ADDENDUM 2

Project: Mentor Ice Arena – East Rink Floor and Plant
Purpose: Pre-bid site walk through with proponents
Meeting Date: Thursday May 28, 2026; 10:00AM
Location: Onsite – Mentor Ice Arena meeting room

East Floor and Chiller Project-Bidder Questions**Received June 1 – Post Site Walk Meeting May 28, 2026**

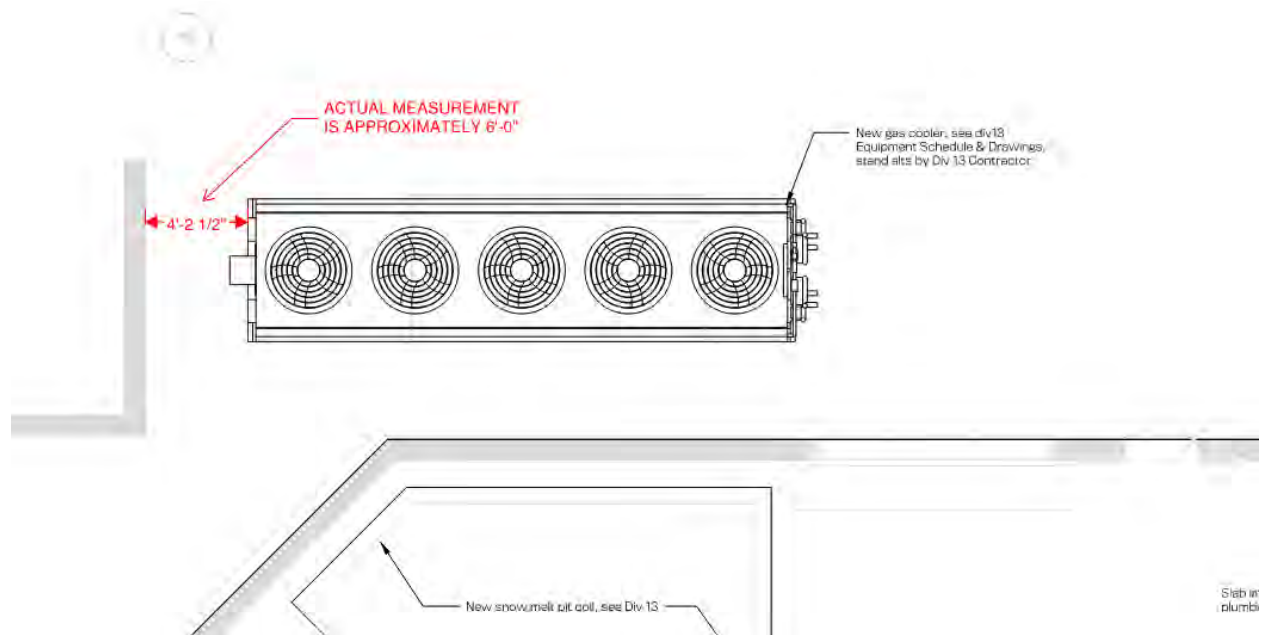
- 1.) Gas Cooler location and size; basis of design Gas Cooler is significantly longer than the current equipment installed at the site. Further complications regarding the egress from the adjacent “alleyway” would create a pinch point. Since there is some design delegation regarding this installation, I am requesting that the following be responded:
 - a. Can the unit elevation be adjusted to a height of 7’0” top of steel to support the equipment which would allow a pass under to accommodate the adjacent egress pathway?

Answer: raise steel beams to 8;0” above Grade as suggested.
